**THE PORT AUTHORITY OF NEW YORK AND NEW JERSEY
TWO MONTGOMERY STREET - 1st FLOOR
JERSEY CITY, NJ 07302**

ADDENDUM NO. 8

TO PROSPECTIVE BIDDERS ON CONTRACT **EW-154.395** – NEWARK LIBERTY INTERNATIONAL AIRPORT – TERMINAL A REDEVELOPMENT PROGRAM BRIDGES N61, N62, N63, AT-GRADE ROADWAYS AND APPURTENANCES AND CONTRACT **EW-154.395M** – NEWARK LIBERTY INTERNATIONAL AIRPORT – AGREEMENT TO PERFORM LANDSCAPE MAINTENANCE

SKETCH SK-MT02
ADDENDUM NO. 8

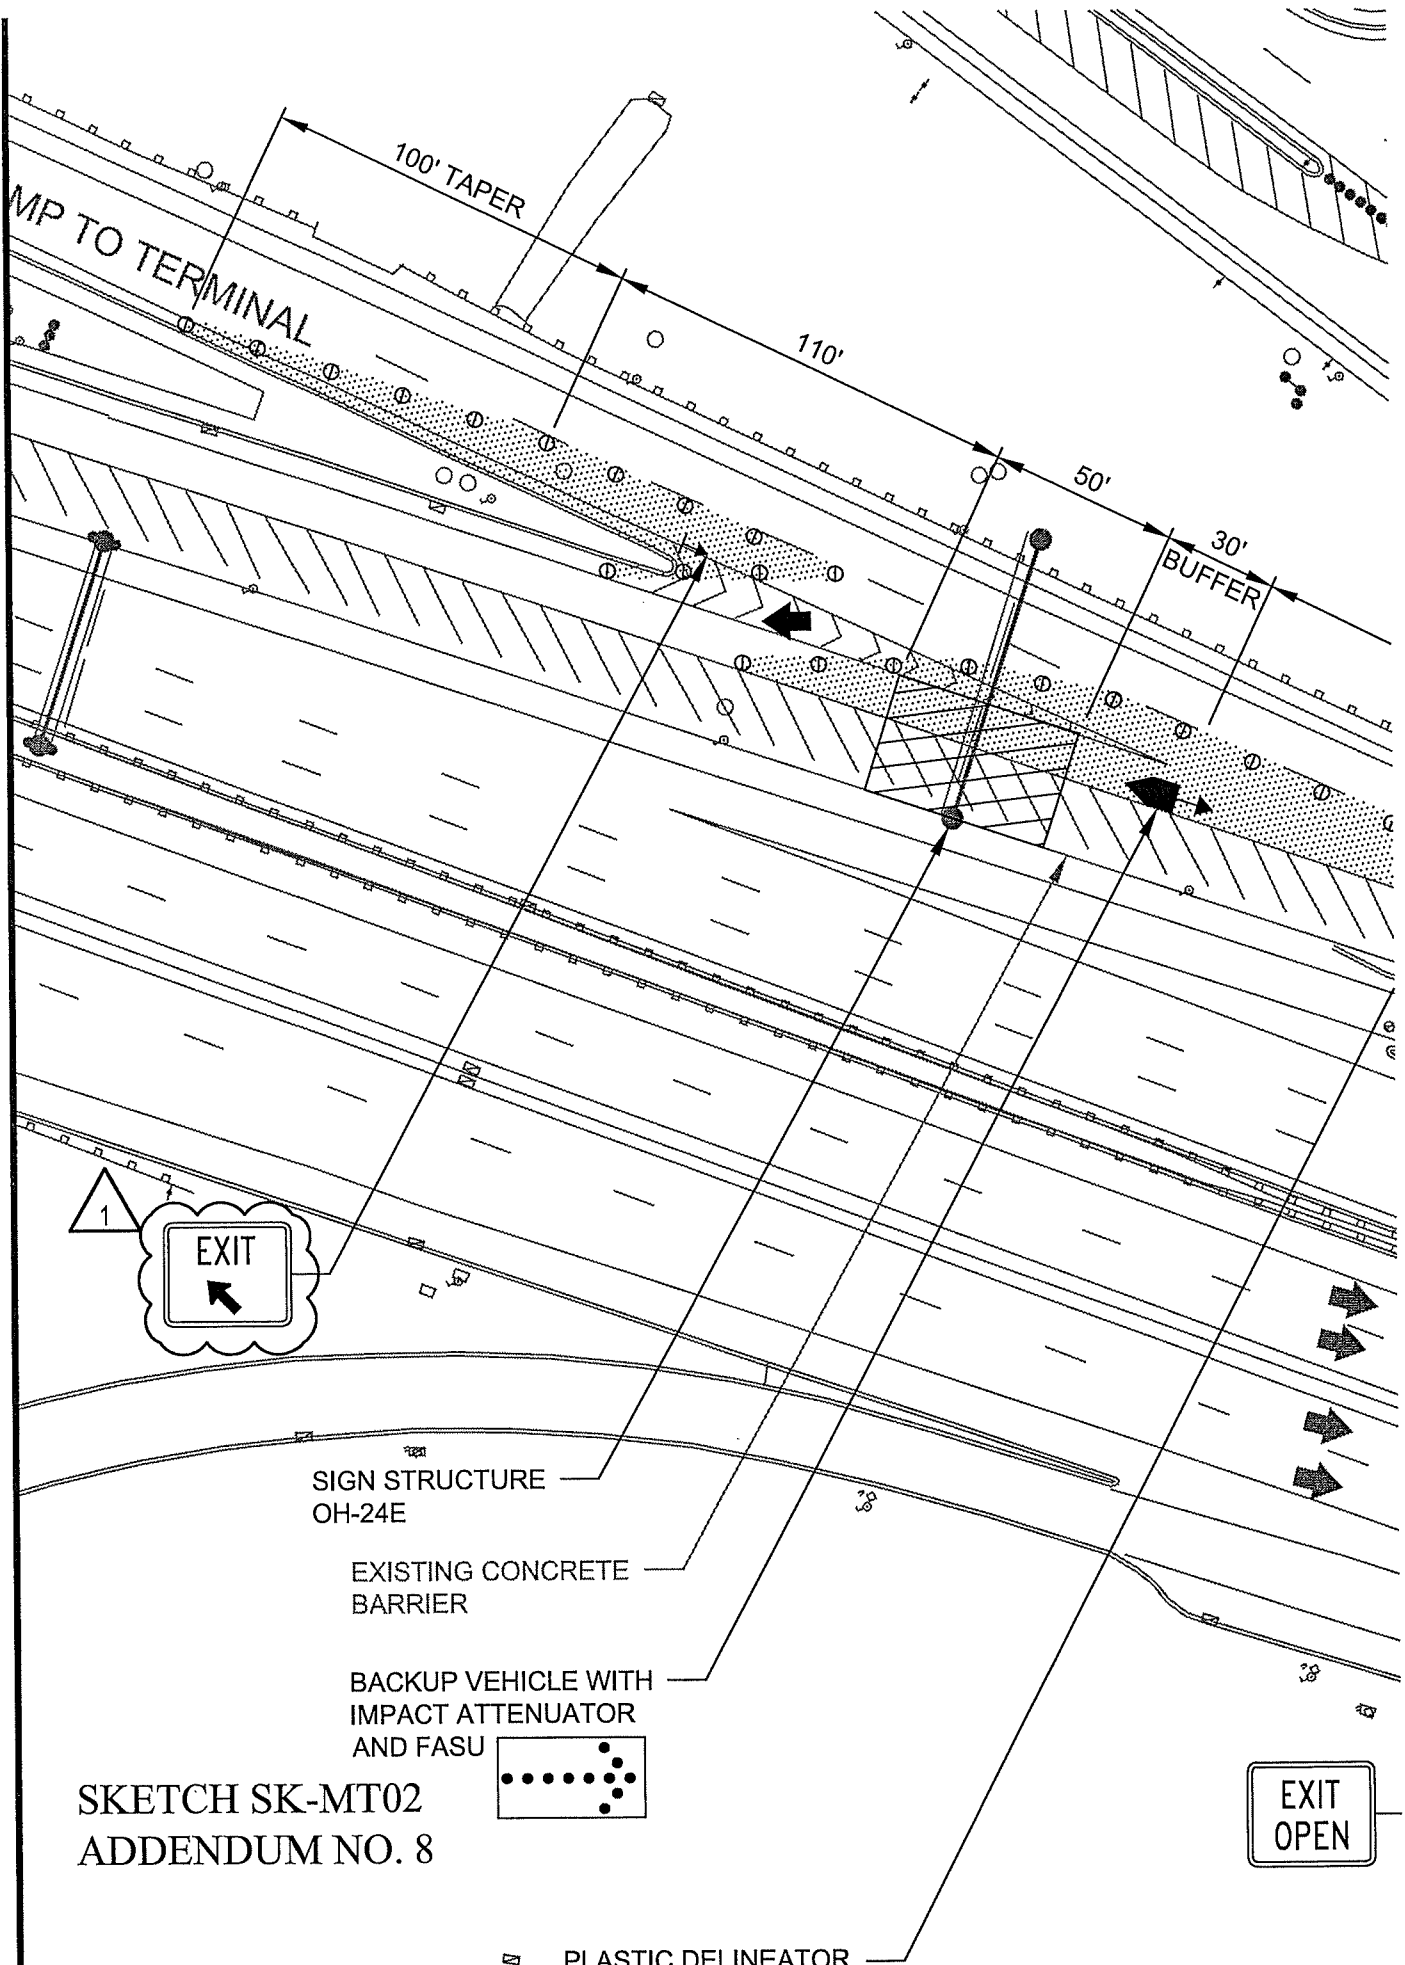
Dwg. MT0435 - Revise the drawing as shown in Sketch SK-MT02 which is attached hereto and made a part hereof.
